UNITED STATES PATENT AND TRADEMARK OFFICE

APPLICATION NO.	FILING DATE	FIRST NAMED INVENTOR	ATTORNEY DOCKET NO.	CONFIRMATION NO.
10/722,574	11/28/2003	Allan Tanghoj	P66852US3	4958
136 7590 12/26/2007 JACOBSON HOLMAN PLLC 400 SEVENTH STREET N.W. SUITE 600 WASHINGTON, DC 20004			EXAMINER GILBERT, ANDREW M	
			ART UNIT 3767	PAPER NUMBER
			MAIL DATE 12/26/2007	DELIVERY MODE PAPER

Office Action Summary

DETAILED ACTION

Annotated Figure 2: Waldman.

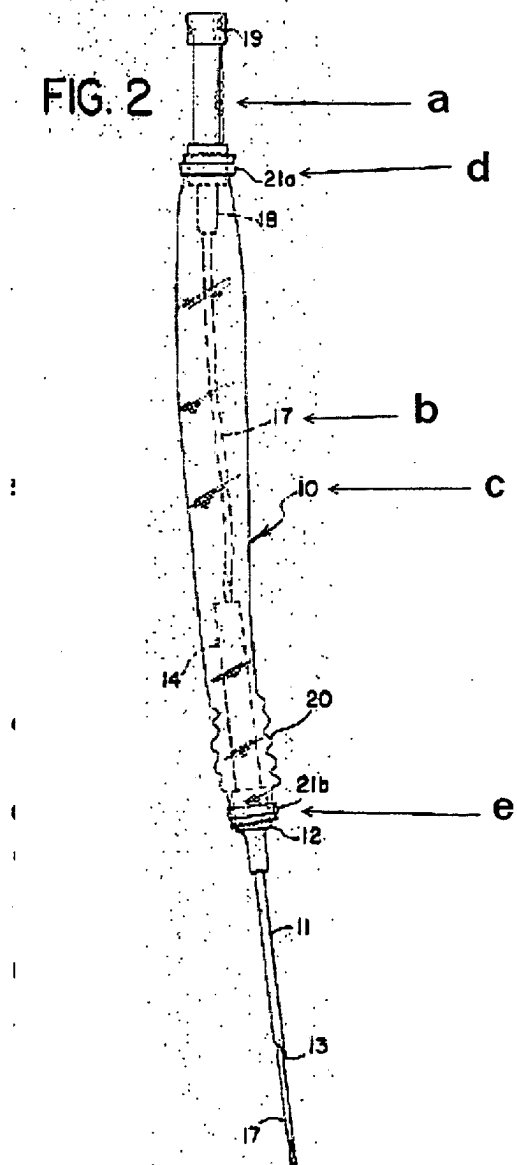
14. In reference to claims 1 and 19, Waldman discloses a kit for preparing a catheter for draining a human bladder, the kit comprising at least a first proximal catheter section

(b; See annotated Figure 2 below) and a second distal catheter section (a); said two catheter sections defining a longitudinally extending passage therein configured to received a flow of urine therethrough from a proximal end portion of said first catheter section to a distal end of said second catheter section, the sections being fixedly connected by a joint (d) and arranged in a coextending fashion with a tubular protective member (c) surrounding said first catheter section, said second distal catheter section being not covered when said kit is configured for storage, the kit further including a joint defining a substantially liquid tight seal (d; col 2) at a distal end of a substantially annular and longitudinally extending cavity provided between the proximal end portion of the first catheter section and an inner wall of the tubular protective member (a, d, c; Fig 2), the tubular protective member being removably connected to the second catheter section (c), so that, when the tubular protective member is removed, said proximal end portion of the first catheter section is exposed and ready for insertion into the human urethra (Figs 1-3; a-e; col 2; wherein the seals are fully capable of being removed as they may be rubber bands or plastic tape; where the Examiner suggests further structurally defining the removing process and/or the structure of the joint and detachable seals to overcome the prior art of record).

15. In reference to claim 6, Waldman discloses wherein a distal end of the second catheter section is provided with a removable liquid-tight seal (d; discussion above).

16. In reference to claim 13, Waldman additionally discloses wherein the tubular protective member is detachably attached to an outer surface of the catheter when the tubular protective member is covering the first catheter section (d; discussion above).

17. In reference to claim 14, Waldman additionally discloses wherein said tubular protective member includes an outward flange at a distal end thereof (e).

18. In reference to claim 16, Waldman additionally discloses a ribbed portion between said first and second sections (18, 21a; d).

19. In reference to claim 17, Waldman additionally discloses wherein said tubular protective member fastens to said second catheter section through engagement with said ribbed portion (a, b, d; col 2).

20. In reference to claim 18, Waldman additionally discloses wherein the tubular protective member fastens to said second catheter section when the tubular protective member is covering the first catheter section (a-d; col 2).
